**INLAND WETLANDS COMMISSION
REGULAR MEETING
MINUTES**

December 13, 2023 @ 7:30 p.m.
Council Chambers, Newtown Municipal Center
3 Primrose Street, Newtown CT

IW Application #23-31 by Castle Hill Real Estate Holdings, LLC, property located at 20 & 60 Castle Hill Road, to construct a cluster home community consisting of 117 single family units, community center and associated site improvements.

SITE PLAN - OVERALL
CASTLE HILL VILLAGE
RESIDENTIAL OPEN SPACE DEVELOPMENT
 20 & 60 CASTLE HILL ROAD
 NEWTOWN, CONNECTICUT

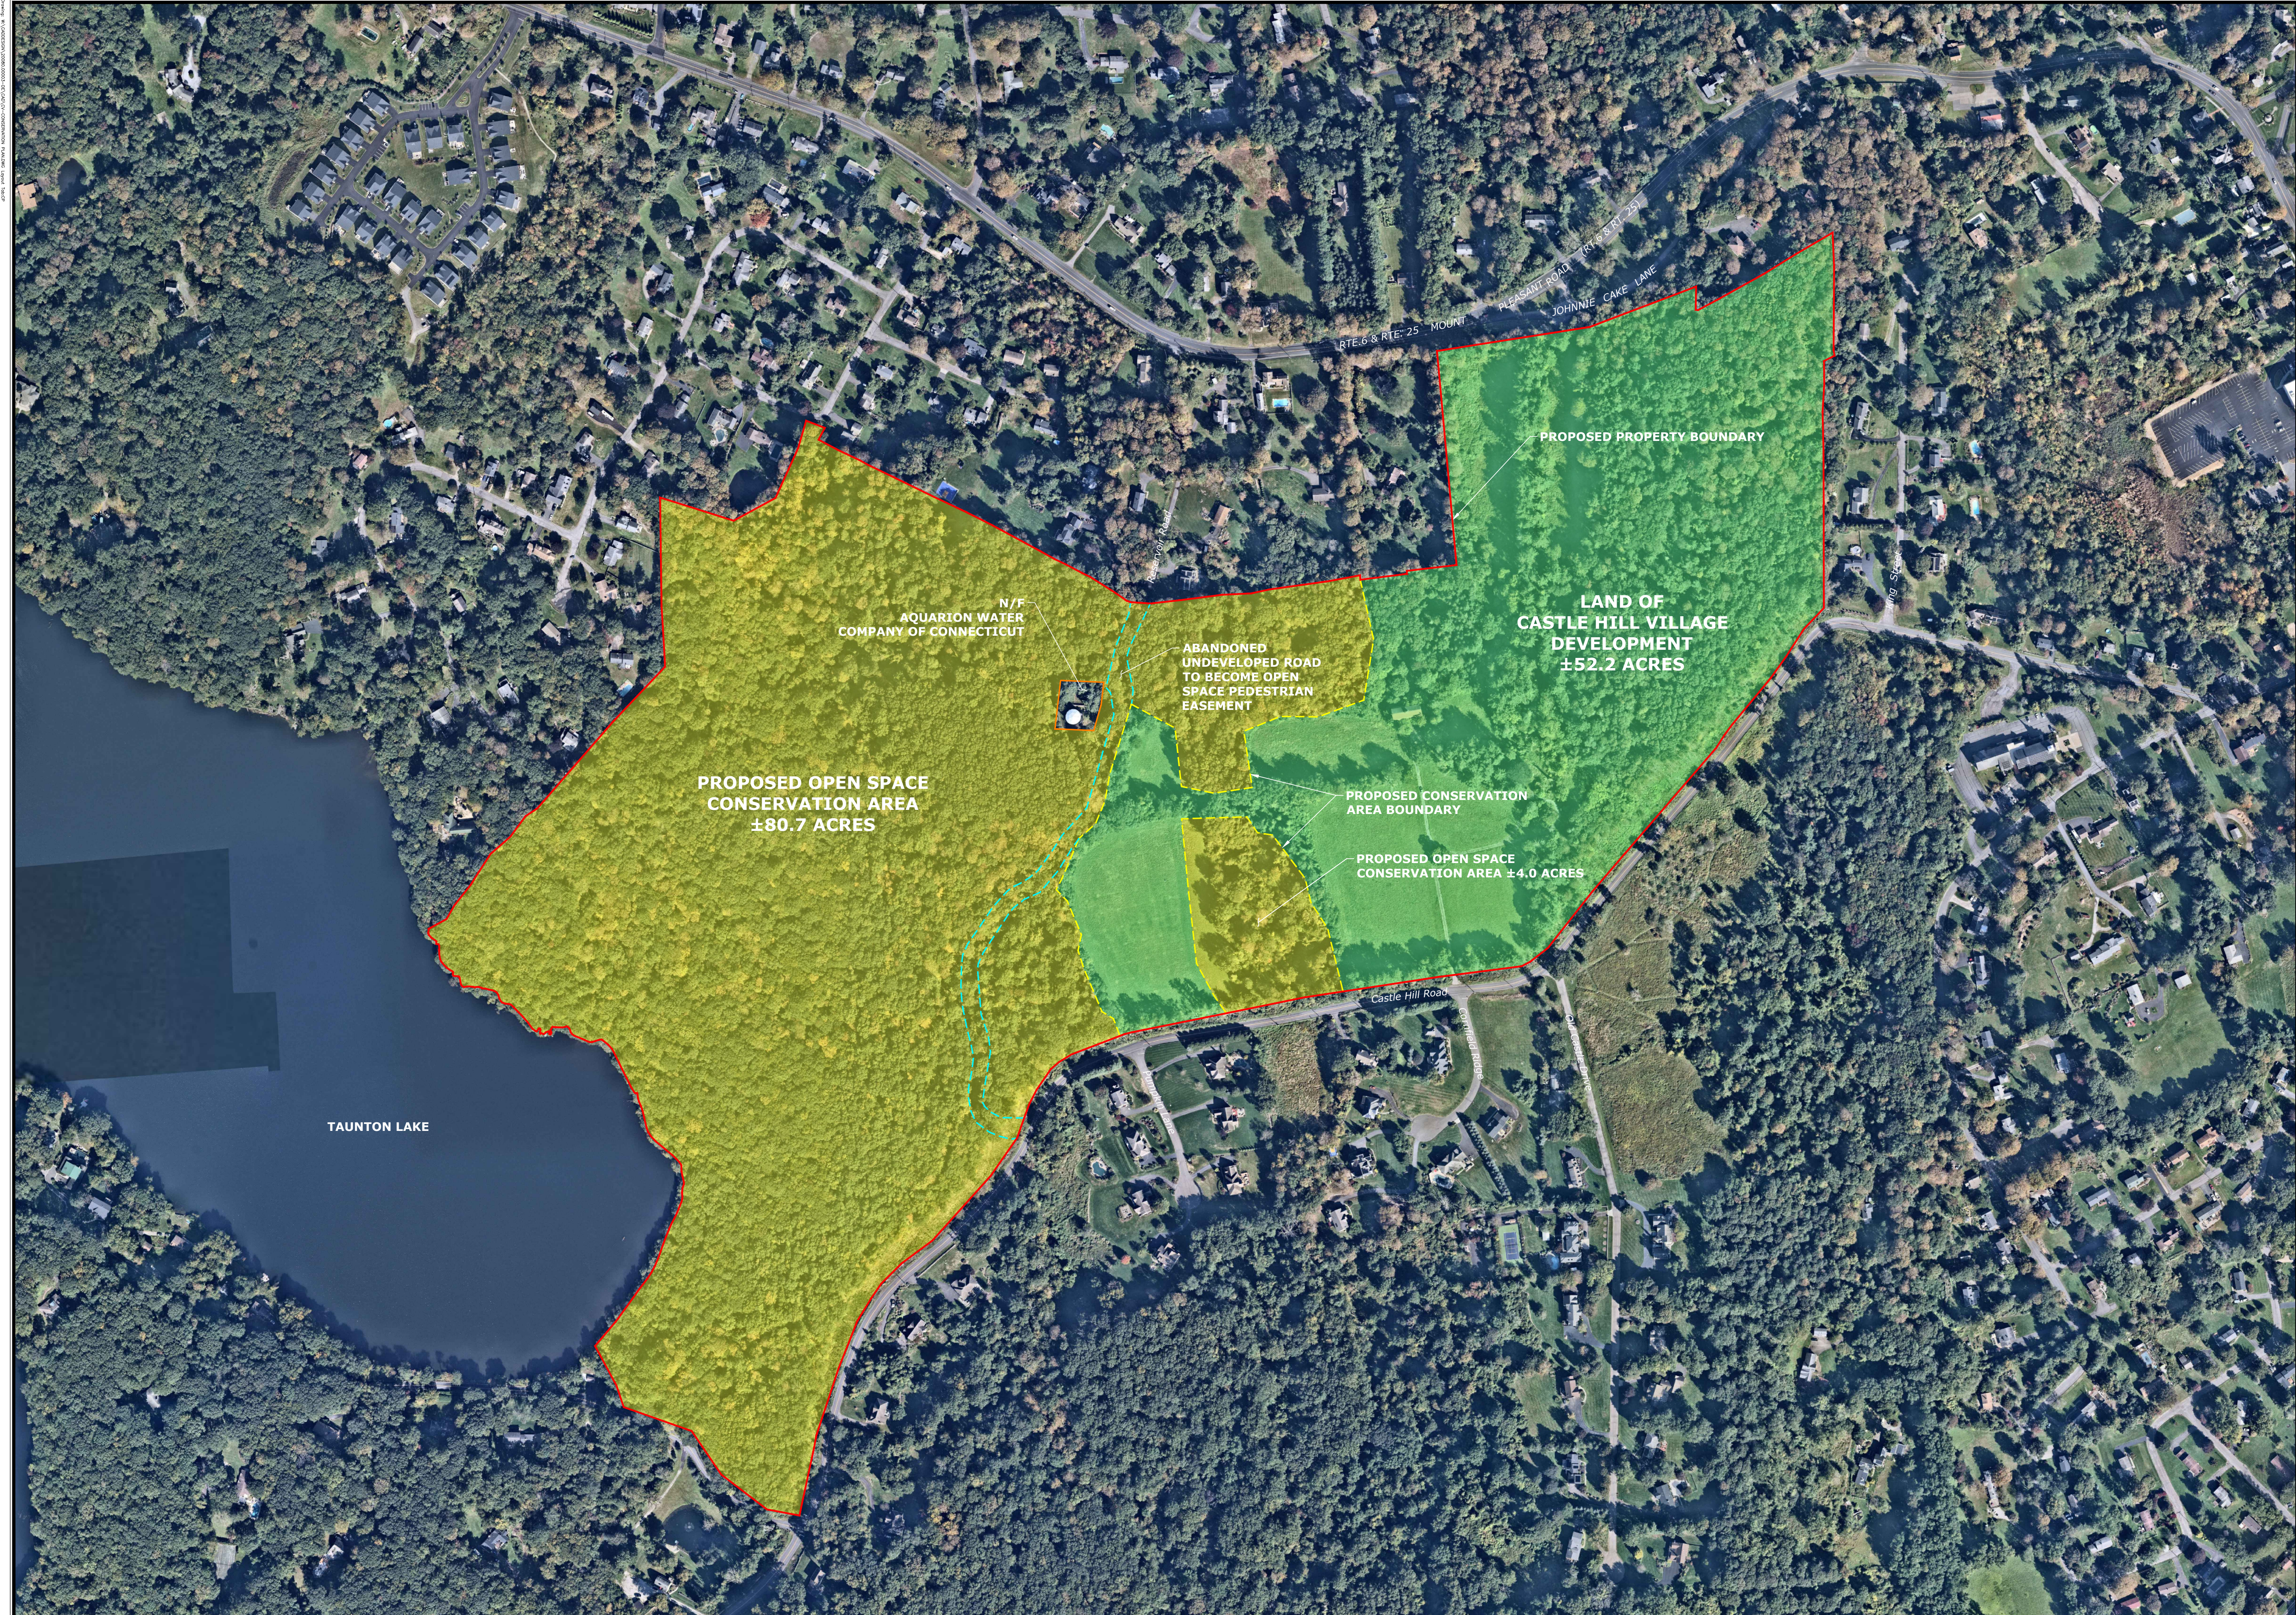
Ms. Guidera requested more information regarding the discharge from the property and the stormwater drainage basins. Mr. Ritchie gave an overview of the "Site Plan – Utilities" page (see attached).

Ms. Guidera asked whether the discharge from the stormwater basins will run into the vernal pool. Mr. Ritchie responded very minimal, if any.

SMM	SMM	TDR
DESIGNED	DRAWN	CHECKED
SCALE: 1"=100'		
DATE: NOVEMBER 8, 2023		
PROJECT NO.: 20080.00003		
SHEET NO.: 27 OF 41		
SHEET NAME: SE

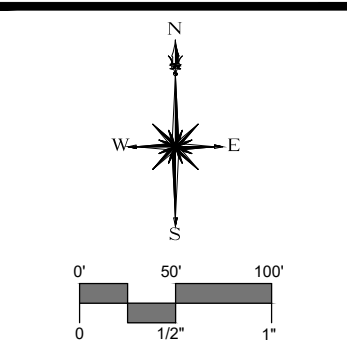
Sheet SE of the plan set is called Construction Phasing. There is no legend or notes on this plan. There is nothing called out to describe how this construction phasing will work. Therefore I have a lot of questions and I am sure the contractor will as well. For example, will all the trees be cut at one time or just in each phase? I didn't see S&E controls between each phase. What determines the completion of a phase? Can you provide a cut/fill analysis for each phase as well?
